Product Change Notification - SYST-07FJOF556

ERRATA - SAM D09 Series Family Silicon Errata and Data Sheet Clarifications

SAM D09 Series Family Silicon Errata and Data Sheet Clarification

The following typographic corrections and clarifications are to be noted for the latest version of the Device Data Sheet (Atmel-42414G-SAM-D09-Datasheet_09/2016).

FIGURE 30-3: BOD33 HYSTERESIS OFF

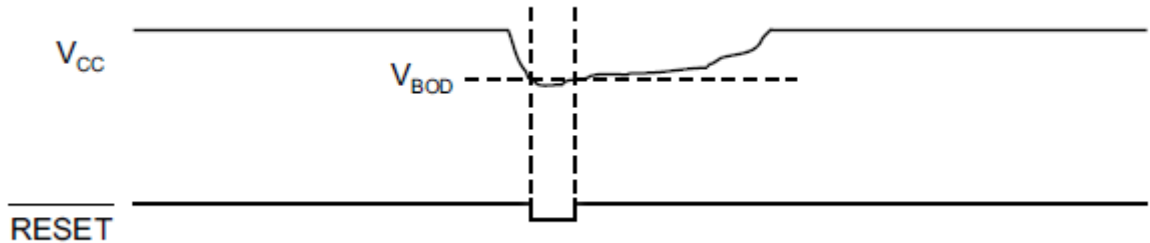
Figure 30-3 and Figure 30-4 have an incorrect reset Polarity value. The corrected figures are as shown below:
